Item Name: Crosstube Turning Detail

Draw Nbr	Revision Nbr
D206-667-243	Rev C

WORK ORDER NON-CONFORMANCE / UPDATE

DRAWING NO. D206-667-243	TITLE CROSSTUBE ASS'Y (206L HIGH AFT)	REV. C	DART AEROSPACE LTD ENGINEERING ORDER		D.E.O. NO. D206-667-243-C-1	SHEET NO. - SHEET 1 OF 1	SCALE NTS
DRAWN <i>qp</i>	CHECKED <i>ASS</i>	MFG. APPR. <i>RB</i>	APPROVED <i>MR</i>		DE APPR. <i>#</i>		
DATE 11.07.15	DATE 11.07.20	DATE 11.07.21	DATE 11/07/21		DATE 11.07.21

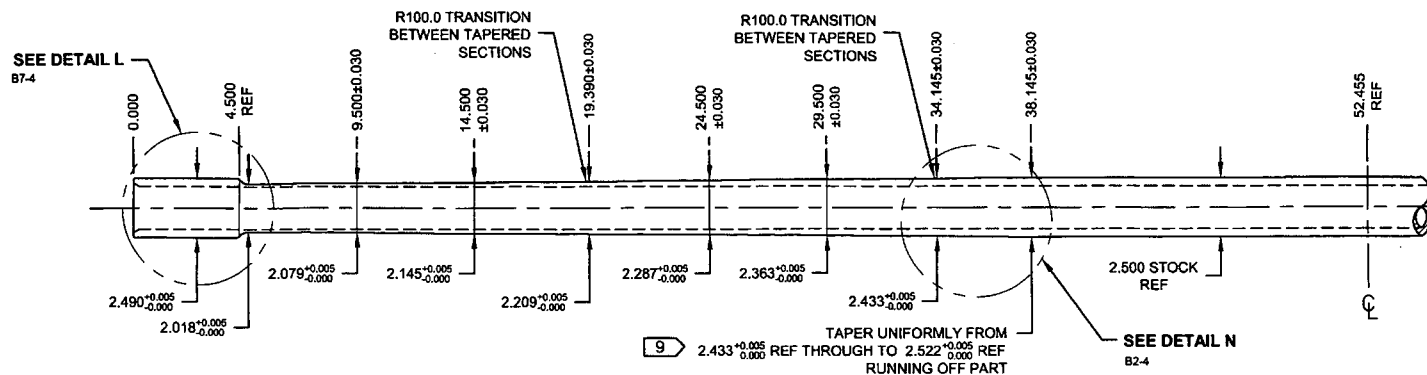
REPLACE MAGNOBOND WITH PROSEAL.

NOTE 12 & 15, SHEET 1 IS AMENDED AS FOLLOWS:

- 12) TO INSTALL D2892-1 SUPPORT: ABRABE MATING SURFACE OF SUPPORT AND CROSSTUBE WITH 180-GRIT SANDPAPER AND REMOVE RESIDUE WITH MEK (OR EQUIVALENT). APPLY A 0.04" TO 0.07" THICK LAYER OF PROSEAL 890 CLASS B-2 (OR AMS-S-8802 CLASS B-2) SEALANT TO MATING SURFACE OF SUPPORT.
- 15) TORQUE CLAMPS 80 TO 100 IN-LB. ENSURE AT LEAST 1.5 THREADS SHOWING IN SAFETY AND THAT NUT HAS NOT BOTTOMED-OUT AFTER TORQUING. **PRIOR TO PACKAGING, RE-CHECK TORQUE ON CLAMPS AFTER PROSEAL 890 SEALANT HAS CURED FOR 72 HOURS.**
